GFA AIRWORTHINESS DIRECTIVE

- TYPE AFFECTED:** SZD-50-3 PUCHACZ:- All aircraft up to Serial No B-2207 and serial No's 503199327, 503A04001, 503A05002 & 503A05003
- SUBJECT:** Flight Controls: Inspection / replacement of airbrake intermediate (Vee shaped) bellcrank mounting bolt & lockwasher.

GFA AD-655 ISSUE 1 PAGE 2 OF 4

SERVICE BULLETIN
No BE-059/SZD-50-3/2007 "PUCHACZ"

Fig. 1. Bolt and washer replacing.

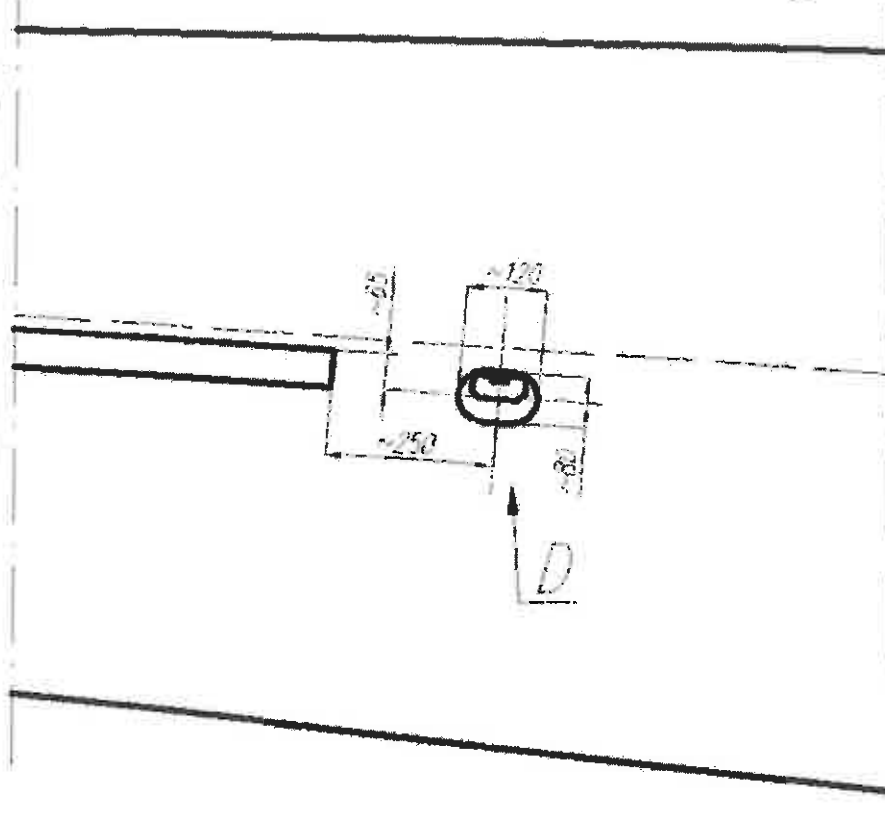
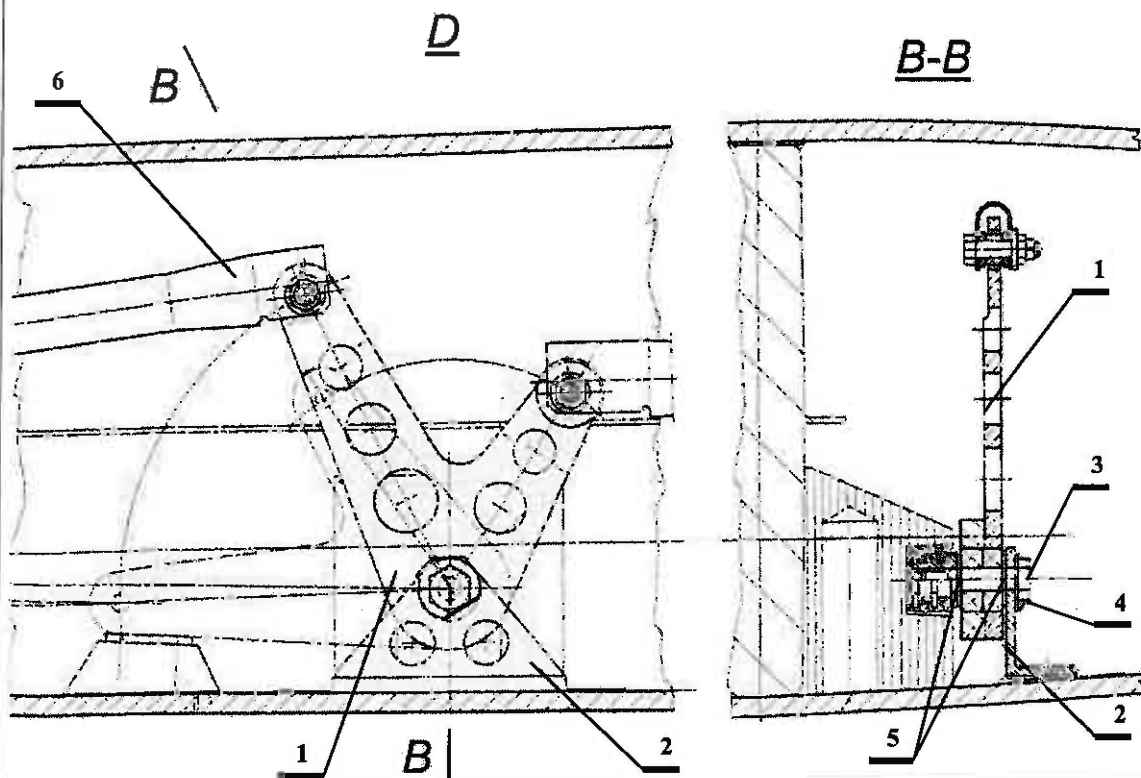
<p style="text-align: center;">Allstar PZL Glider Sp. z o. o.</p>	<p style="text-align: center;">SERVICE BULLETIN No BE-059/SZD-50-3/2007 "PUCHACZ"</p>	<p style="text-align: right;">Page: 3 of : 4</p>
<p>6. REPLACING OF BOLTS AND WASHERS. Replacing of bolts and washers must be performed by certified maintenance organization.</p> <p>6.1. De-rig the wing.</p> <p>6.2. Cut a hole in upper skin of the wing, according to Fig. 1.</p> <p>6.3. Screw out and remove bolt M8x34, remove also spring-lock washer and spacer washers (5).</p> <p>6.4. Screw in bolt M8x32 (3), with a tab washer (4) as a locking device, inserting also spacer washers (5) on their place.</p> <p>6.5. Bend a tab of the tab washer (4) on the lever console (2) as shown in "D" view. Bend tab washer on the bolt (3) head, at arbitrary selected position.</p> <p>6.6. After ensuring that assembling has been performed correctly, and bolt reliably locked by tab washer bent, repair the hole in wing skin according to Repair Manual of the glider.</p> <p>7. PARTS NECESSARY FOR REPLACEMENT.</p> <p>7.1. Tab washers can be purchased from Allstar PZL Glider, or similar can be used, for example FABORY no. 51540 M8. Washer's tab is to be cut to 15 mm.</p> <p>7.2. Bolt M8x32 must be purchased from Allstar PZL Glider.</p> <p>8. FINAL CONCLUSIONS.</p> <p>8.1 Replacing of bolts and washers in accordance with point 6 of current bulletin is to be recorded at appropriate position in a Glider Log Book.</p> <p>8.2. For gliders verified during inspection as in point 5.1, introduce following revisions in Technical Service Manual (TSM):</p> <p>8.2.1. In TSM issue III, september 1980 and issue IV, may 981 in point 3.4. in column 'Maintenance work' in rows 'After every 100 flying hours' and 'On the end of flying season or before the prolonged hangaring' add 'Bulletin BE-059/SZD-50-3/2007'.</p> <p>8.2.2. In TSM issue I/JAR-22, may 1994 in point 15.7 in column 'Maintenance work' in row 'After every 100 flying hours' add 'Bulletin BE-059/SZD-50-3/2007'.</p> <p>8.2.3. Introduced revisions must be recorded in Record of Revisions in TSM..</p> <p>8.2.4. After replacing bolts and washers according to point 6 of current bulletin, cancel revisions recorded according to points 8.2.1. or 8.2.2. Cancellation must be recorded in Record of Revisions in TSM.</p> <p>8.3. If loosen bolt is detected, Operator of the glider is requested to notify Allstar PZL Glider on this fact, specifying: Serial Number of glider, total flight time, number of landings, and Operator/Owner data.</p> <p>8.4. The operator is introducing this Bulletin at his own cost.</p> <p>9. DESCRIPTION OF FIG. 1.</p> <p>1- intermediate lever in airbrake control system</p> <p>2- lever's console</p> <p>3- M8x32 bolt</p> <p>4- tab washer</p> <p>5- 8,5x1 washer</p> <p>6- pushrod</p>

- ACTION REQUIRED:** In accordance with the above SB carry out the following actions.
ACTION 1. BEFORE FURTHER FLIGHT:- Inspect both wings for loose bolts securing the intermediate bellcranks. If any loose bolts are found, ***PRIOR TO THE NEXT FLIGHT*** BOTH M8x34 bolts must be replaced using M8x32 bolts, and the lockwashers must be replaced with locktabs. If no loose bolts are found, the aircraft may be returned to service provided that the inspection is repeated every 100 flying hours or 12 months whichever occurs first, until Action 2 has been accomplished.
ACTION 2. Unless performed as a result of Action 1, during the next 1000 hour inspection the M8x34 bolts must be replaced with M8x32 bolts and the split washers replaced with locktabs. It may be found more convenient to accomplish this at the next Form II.
